SUBJECT: Forwards response to 980413 RAI re TS change 95-03,  
addressing newly installed MSLB protection circuitry.

Subject: Oconee Nuclear Station  
Docket Nos. 50-269, -270, -287  
Proposed Revision to Technical Specifications  
Technical Specification Change # 95-03  
Response to Request for Additional Information #3

RESPONSE TO REQUEST FOR ADDITIONAL INFORMATION

**Figure 1**  
**Oconee Steam Line Break With Continued MFW Addition: Containment Pressure**

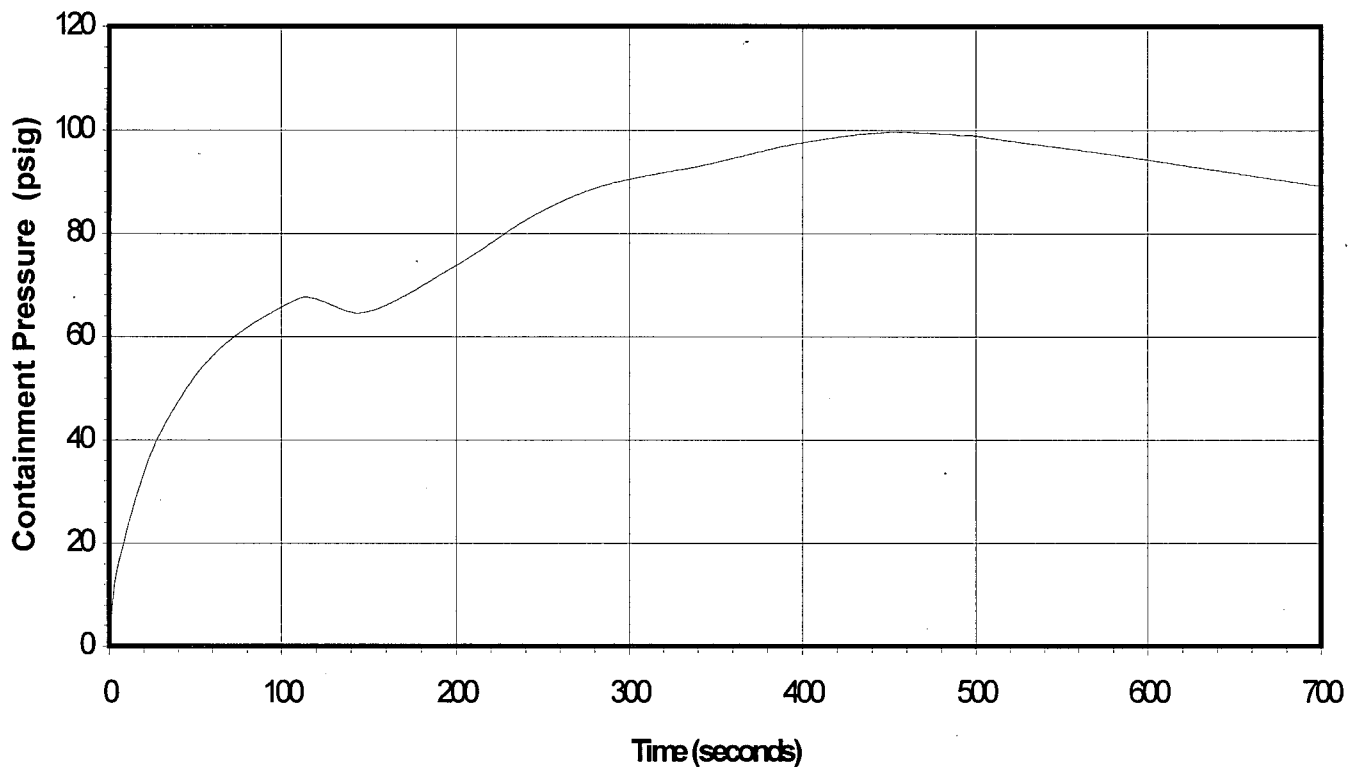
Provide the results of a containment analysis (as requested by Bulletin 80-04) that reflects the actual design of the MFW isolation capability at Oconee. The analysis should assume that feedwater continues to be added to the faulted steam generator (via the condensate pumps) for ten minutes (assumed for operator action to secure flow) or for the time it takes to isolate MFW flow via the MFW block valves if they can close under the differential pressure associated with the condensate pumps. The analysis can take credit for all containment cooling features, since no other single failures need be assumed. The analysis should also assume that offsite power is available since the condensate pumps would not be running for a loss of offsite power.

An analysis was performed for a main steam line break (MSLB) with continued feedwater addition to the faulted steam generator via the condensate booster pumps for ten minutes due to the failure of the main feedwater (MFW) control valve to close. The MFW block valves are assumed to be unable to close under the differential pressure associated with the condensate pumps. It is assumed that the MSLB Detection and Feedwater Isolation System functions to trip the MFW pumps and the turbine-driven emergency feedwater (EFW) pump, and to close the MFW control valve to the unaffected steam generator. Since a failure of the MFW control valve to the affected steam generator is assumed, no other single failure is postulated. Thus, two trains of high pressure injection (HPI) are credited and the EFW flowrate is controlled to maintain steam generator level at the control setpoint. Credit is taken in the analysis for all containment cooling features. Offsite power remains available.

The methodology used to perform the FATHOMS containment analysis is detailed in topical report DPC-NE-3003-PA, "Mass and Energy Release and Containment Response Methodology." Three reactor building cooling units (RBCUs) and two spray trains are assumed to be available. The RBCU actuation signal occurs at 2 seconds, and the units are running at 80 seconds. The containment spray actuation signal occurs at 17 seconds, and the spray flow starts at 109 seconds. Containment pressure increases steadily until the peak containment pressure (Figure 1) of 100 psig is reached at 445 seconds. The containment pressurization is terminated by the decreasing break flowrate as well as the change in the break flow from steam to liquid. The simulation is run for 700 seconds.

Duke performed a containment analysis to allow the NRC staff to assess the design of the MFW isolation capability at Oconee. The analysis assumed that feedwater continued to be added to the faulted steam generator, via the condensate pumps, for ten minutes. The analysis took credit for all containment cooling features since no other single failures were assumed. The analysis also assumed that offsite power was available. The analysis indicated that a peak reactor building pressure of 100 psig is reached at 445 seconds into the accident simulation. The containment temperature exceeded the equipment qualification limit during the 700 second transient simulation. However, this requested analysis is considered to be outside Oconee's current licensing basis. UFSAR Chapter 6 describes Oconee's current limiting MSLB analysis with respect to containment temperature and pressure.

INSTRUMENT DETAILS  
 MAIN FDW VALVE CONTROL  
 IFDW-32 & IFDW-4

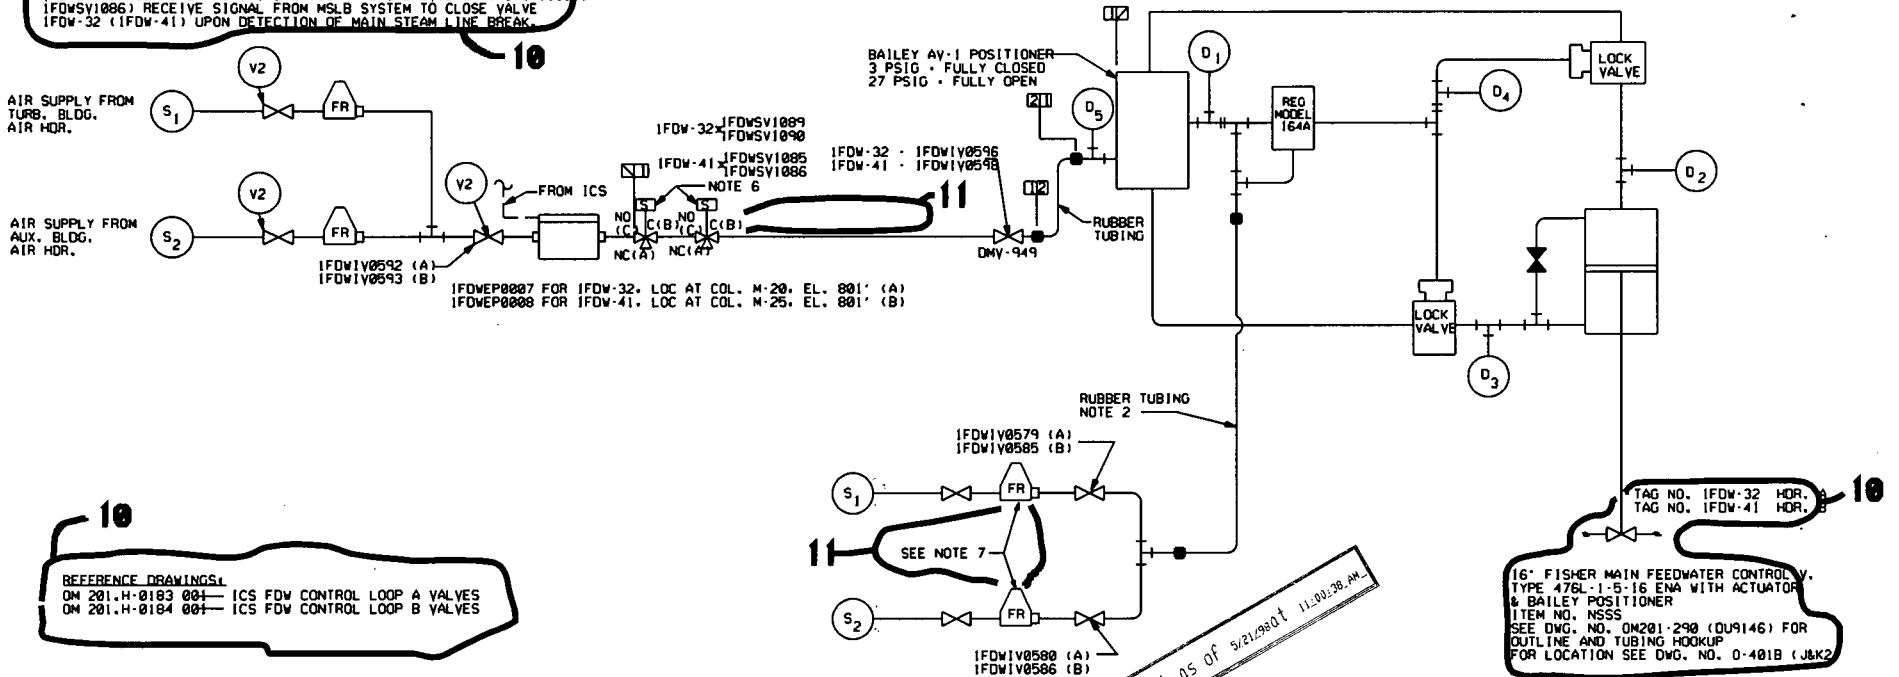
Identify all of the single active failures that could cause a MFW control valve not to go closed following an MSLB actuation signal; e.g., loss of power, loss of air, failure of the actuation circuitry, failures in the integrated control system, etc.

For normal operation under the Integrated Control System (ICS), the MFW control valves receive an instrument signal (3-27 psig) from E/P # 1FDWEP0007 or 8. This signal goes to the Bailey positioner on the valve. The positioner interprets the signal to open, modulate, or close the valve via the actuator. If supply air is lost, the trip lock valves will lock the actuator in the last controlled position. Each actuator is equipped with a manual handwheel to close the valve if required. See the attached instrument detail.

The MSLB circuitry that closes the MFW control valve is comprised of two solenoid valves, one per each train of MSLB, in series between the electric/pneumatic (E/P) converter and the pneumatic MFW control valve positioner. Upon a MSLB actuation either or both of these solenoids will energize which vents the pneumatic signal going to the pneumatic MFW valve positioner. When the pneumatic signal is vented, the valve closes. The MSLB initiating components (solenoids) are downstream of the ICS component (E/P). A single failure in the ICS will not affect the operation of the MSLB circuitry. The circuitry and instrumentation of the MSLB is powered from two separate vital power panel boards. Therefore, no single active failure to the electrical/electronic controls would cause a MFW control valve not to go closed following a MSLB actuation.

- A rupture of the supply air tubing to the positioner would result in the actuator not being able to close the valve.
- A rupture of the air output tubing from the positioner to the upper chamber of the actuator would result in the actuator not being able to close the valve.

- A failure of the valve positioner could cause the valve to fail as-is, open, or close.
- If the actuator stem to valve stem coupling fell off, then the actuator would not be capable of fully closing the valve.
